- **COOLING SYSTEM—3.8L—UNDETERMINED LOSS OF COOLANT**
- **COOLING SYSTEM—4.2L—UNDETERMINED LOSS OF COOLANT**
- **ENGINE—3.8L—ENGINE OIL CONTAMINATED WITH COOLANT**
- **ENGINE—4.2L—ENGINE OIL CONTAMINATED WITH COOLANT**

**Article No.
99-20-7**

FORD: 1996-1997 THUNDERBIRD
1996-1998 MUSTANG, WINDSTAR
1997-1998 E-150, E-250, F-150

This TSB article is being republished in its entirety to correct the front cover/water pump bolt torque values and the Front Cover Gasket Part Number.

Figure 1 - Article 99-20-7

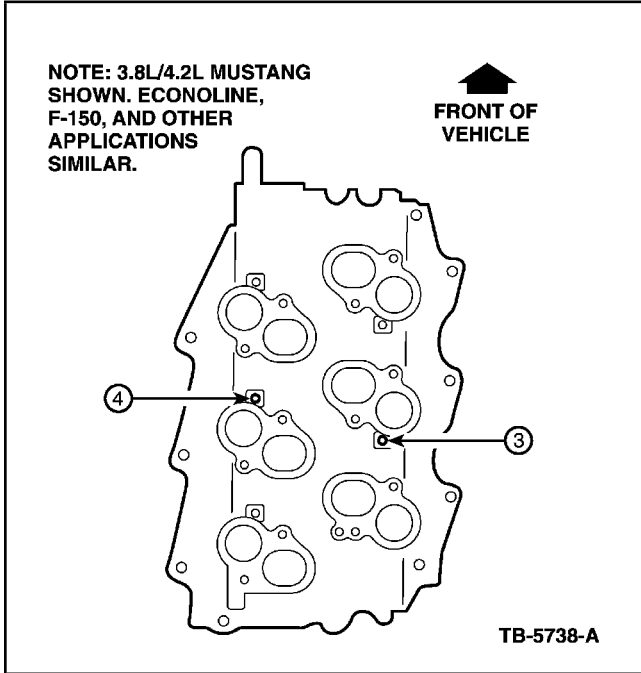
DUE TO SLIGHTLY THICKER SIDE GASKET BEAD MATERIAL, THE CENTER BOLTS (#3 AND

#4, FIGURE 1) IN THE LOWER INTAKE MANIFOLD MUST FIRST BE INSTALLED (HAND-TIGHTENED) AND FASTENED. DRAWING DOWN THESE BOLTS FIRST, WILL FACILITATE INSTALLATION OF THE OTHER BOLTS.
